6/23/10	Revised Typical Tangent Section Detail
DATE	REVISION
STATE OF HAWAII DEPARTMENT OF TRANSPORTATION HIGHWAYS DIVISION	
<u>TYPICAL SECTION</u>	
PALI HIGHWAY PAVEMENT REPAIRS Vicinity of Laimi Road towards Puiwa Road Project No. 61A-01-10M	
Scale: As Shown	Date: April, 2010
SHEET No. 1 OF 1 SHEETS

"AS-BUILT"

ADD.7

TYPICAL TANGENT SECTION

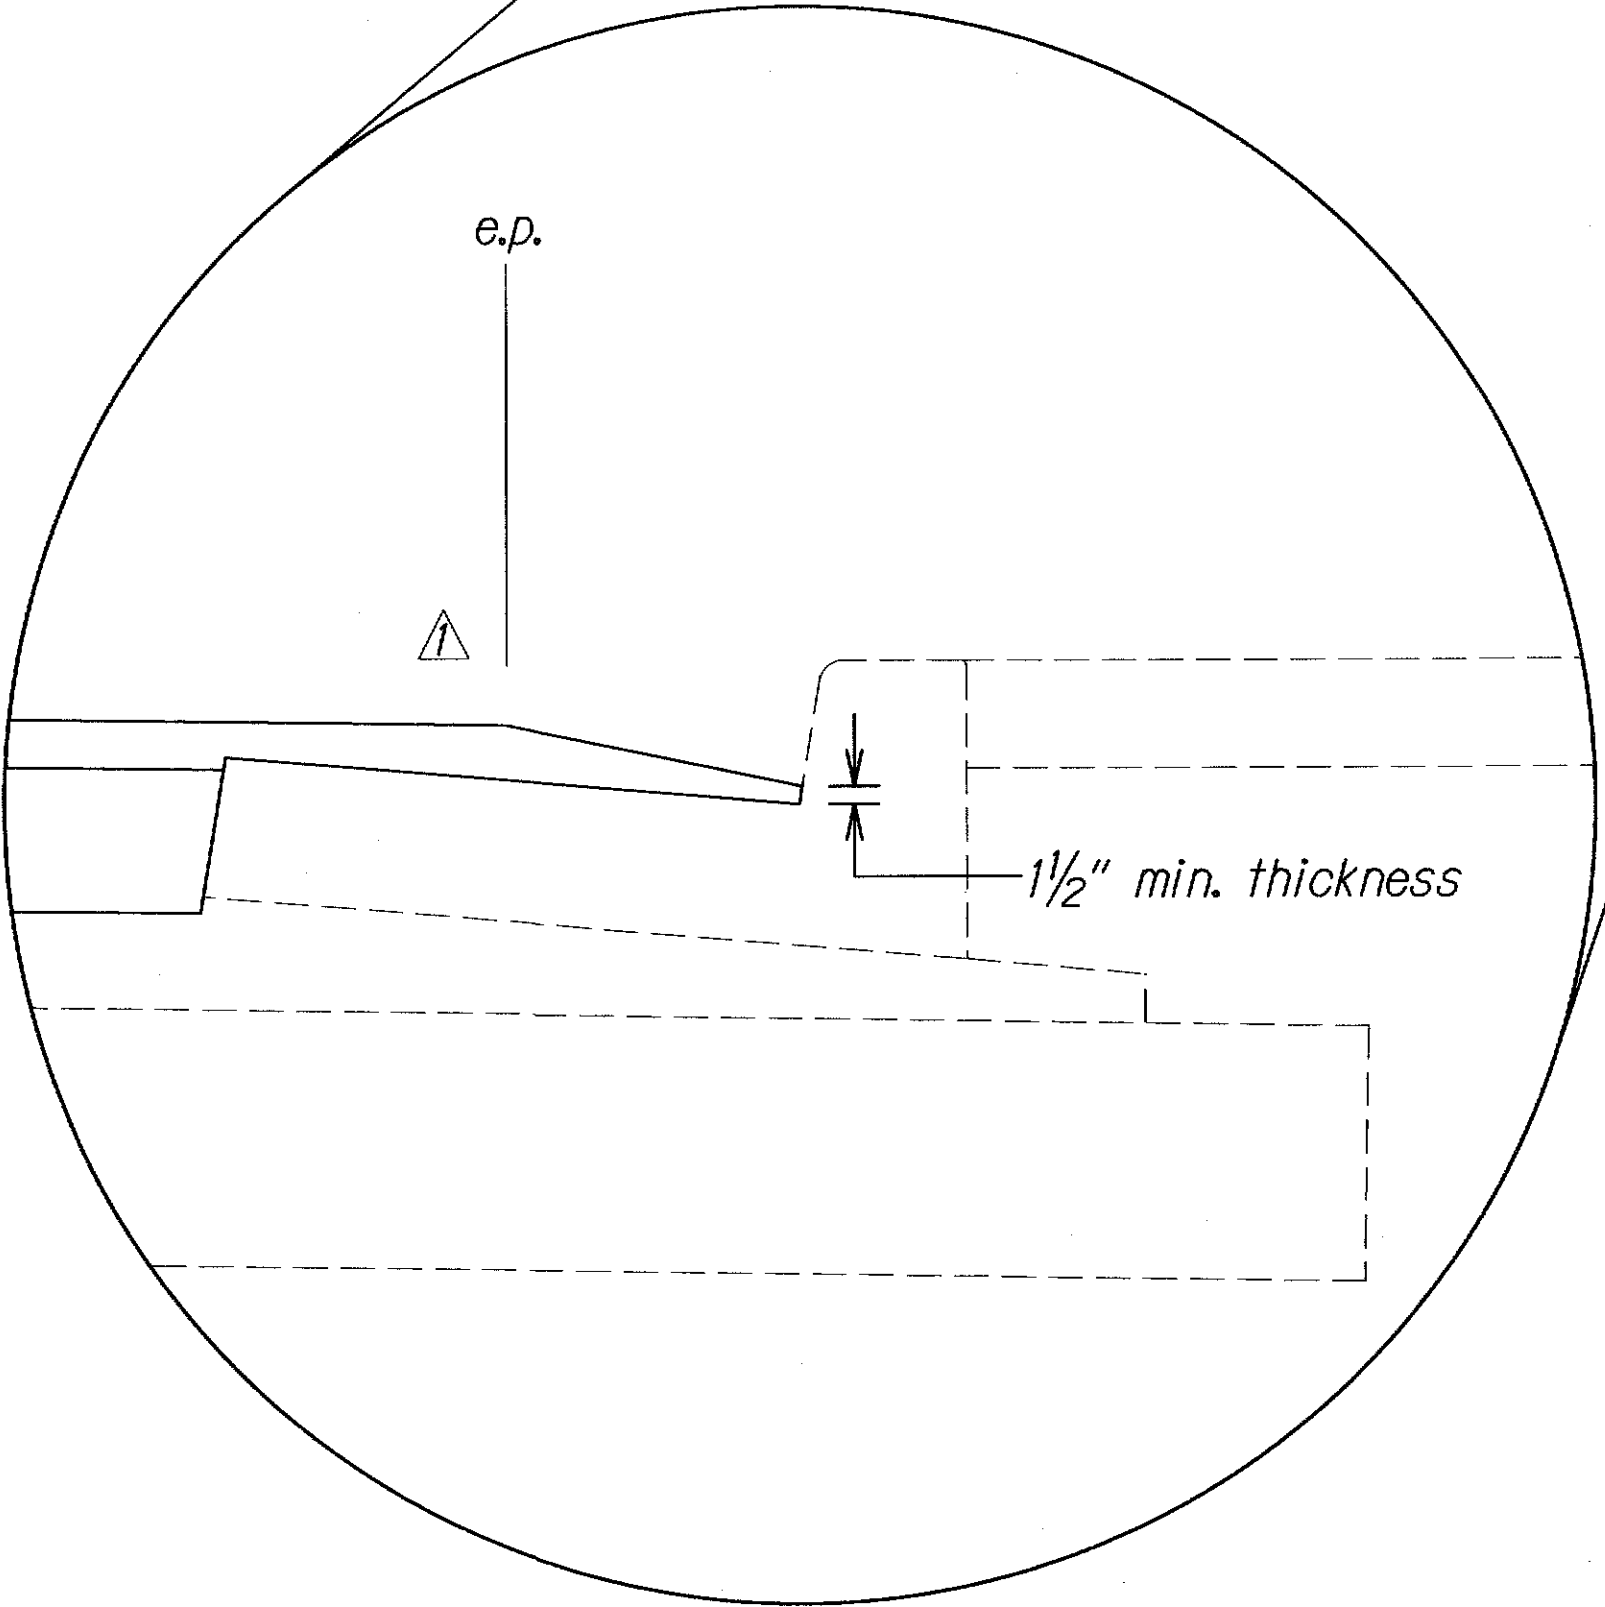
Notes: If aggregate in the existing waterbound macadam base course are loose and cannot be locked together through extensive rolling, remove the 4" WBM Base Course layer to the top of the existing subbase course and replace with Glassphalt Base Course. Removal and replacement of WBM course layer to be paid under Item No. 202.1000 Removal of Existing Water bound Macadam Base Course.

Post Construction Notes:  
Aggregate in the existing waterbound macadam base course were not loose. Rolling, removal, and/or replacement were not necessary.
